**CITY PLAN COMMISSION**

**FILE NUMBER:** S223-080

**REQUEST:** An application to replat a 0.595-acre tract of land containing all of Lots 10, 11, and 12 in City Block B/2104 to create one lot on property located on Samuell Boulevard at Sibley Avenue, southwest corner.

**PRELIMINARY PLAT**  
**ONE SAMUEL ADDITION**  
LOT 1, BLOCK 82104

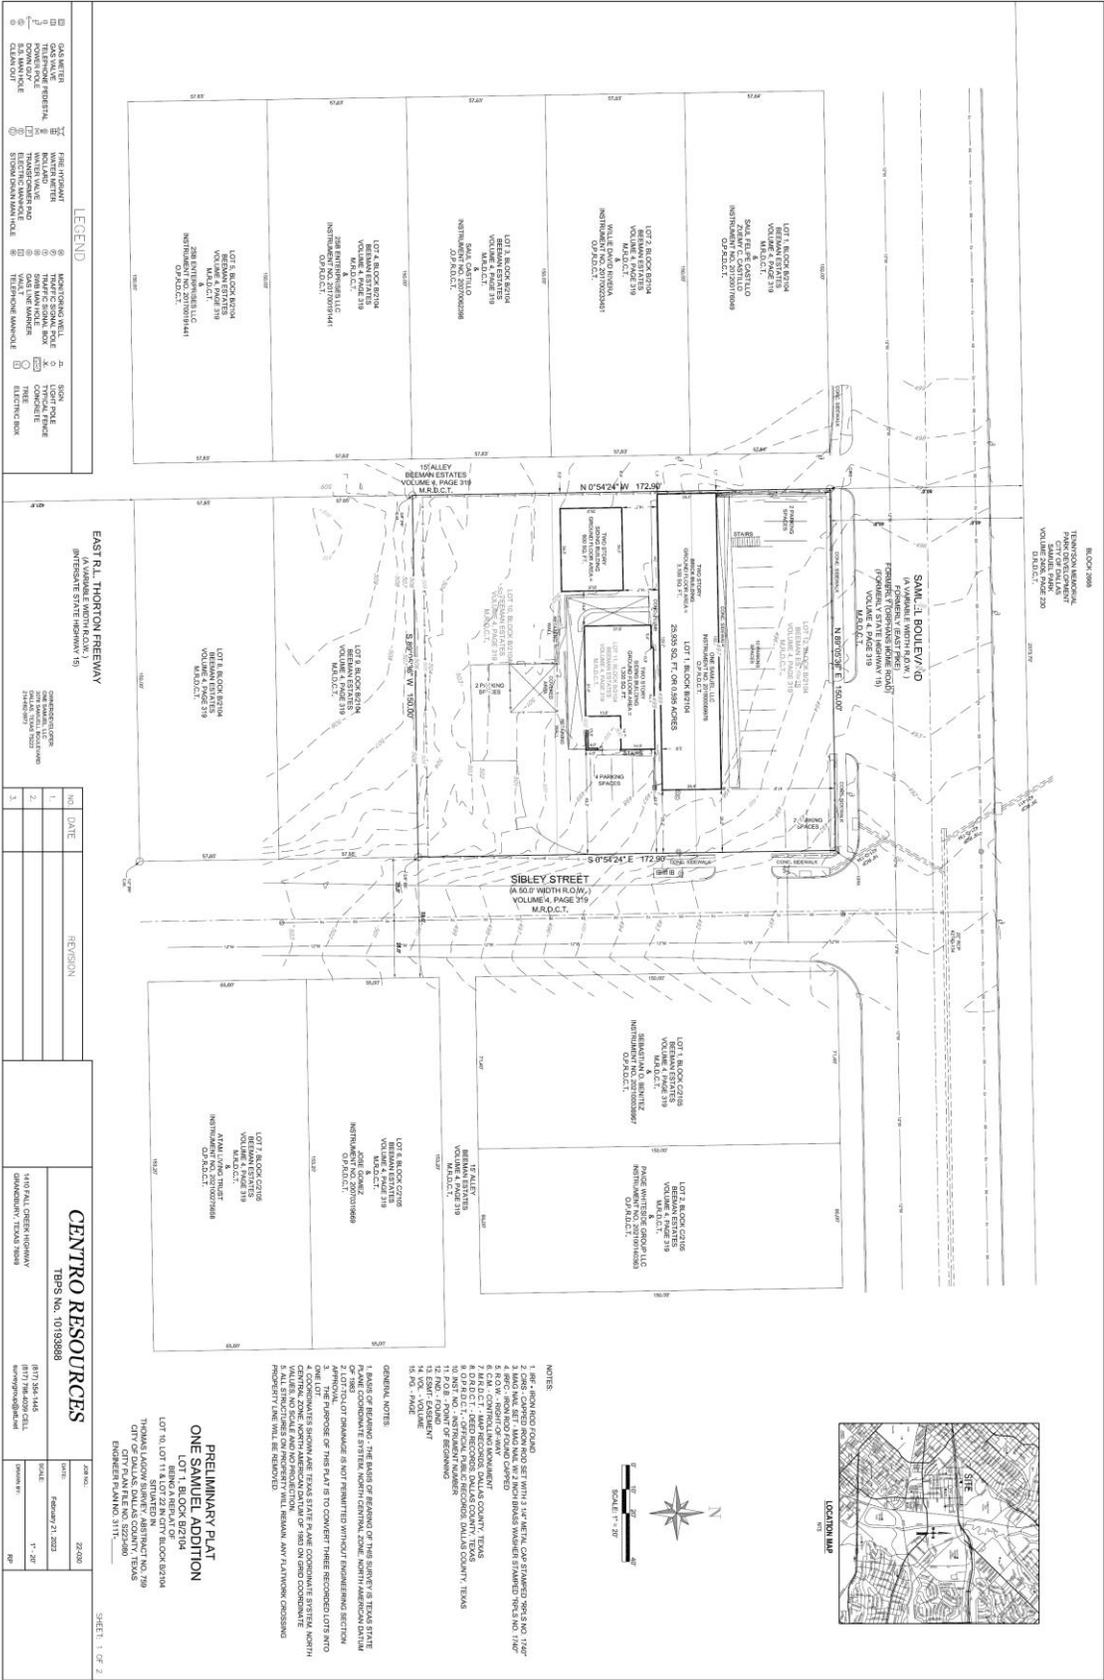
12. Submit a full set of Civil Engineering Plans (drainage, paving, street signage/markings/lighting) prepared per City Standards by a licensed (TX) Professional Engineer to Engineering Division in Room 200, Oak Cliff Municipal Center (i.e., 311T/DP). Additions and alterations to the public infrastructure require approval and may require private development contracts with bonds. 51A-8.102 (c); 8.601(b)(4),(5),(6),(7),(8),(9)
13. Detention may be required if the capacity of available outfall is not adequate to carry the developed runoff. Section 51A-8.611(c).
14. Place a note on the final plat stating "Lot-to-Lot drainage will not be allowed without proper City of Dallas Engineering Division approval" 51A 8.611(e)

15. On the final plat, dedicate 28 feet of right-of-way (via fee simple or street easement) from the established centerline of Sibley Avenue. Sections 51A-8.602(c), 51A-8.604(c) and 51A-8.611(c).
16. On the final plat, dedicate a minimum 10-foot by 10-foot corner clip (via fee simple or street easement) at the intersection of Sibley Avenue and Samuell Boulevard. Section 51A 8.602(d)(1)
17. Prior to final plat, a larger corner clip may be requested during engineering plan and traffic review to accommodate an adequate turning radius, or to maintain public/traffic appurtenances, within the area of the corner clip. Section 51A 8.602(d)(1), 51A 8.608(a)
18. On the final plat, dedicate a 15-foot by 15-foot Alley Sight Easement at the intersection of Samuell Boulevard & the alley. *Section 51A-8.602(e)*

19. Prior to final plat, submit a completed final plat checklist and all supporting documents.
20. On the final plat, show recording information on all existing easements within 150 feet of the property.
21. On the final plat, show all additions or tracts of land within 150 feet of the property with recording information. Platting Guidelines.

22. On the final plat, show or list the prior plat on the map, in the legal description, and/or title block. Platting Guidelines.

23. Additional design information is required for assessment. Site plan must be submitted showing proposed development, building finished floor elevation, development, existing mains – including downstream manhole, and proposed water and wastewater service locations. Submit water/wastewater engineering plans to 320 E. Jefferson Blvd., Room 200, Attention: Water and Wastewater Engineering.

24. Prior to final plat, provide documentation to Real Estate Department to ensure fencing located in the right-of-way of Sibley Avenue is relocated into boundary of the property or removed.
25. On the final plat, change “Samuel Boulevard Formerly (East Pike) Formerly (Orphans Home Road)(Formerly State Highway 15)” to “Samuell Boulevard (F.K.A. East Pike)”. Section 51A-8.403(a)(1)(A)(xii)
26. On the final plat, change “East R.L. Thornton Freeway (Interstate State Highway 15)” to “R.L. Thornton Freeway / Interstate Highway No. 30 (A.K.A. U.S. Highway No. 67)” Section 51A-8.403(a)(1)(A)(xii)
27. On the final plat, change “Sibley Street” to “Sibley Avenue”. Section 51A-8.403(a)(1)(A)(xii)
28. On the final plat, identify the property as Lot 10A in City Block B/2104. Ordinance 1A, Page 131 pages 131-148, Section 2 (passed August 13, 1872).
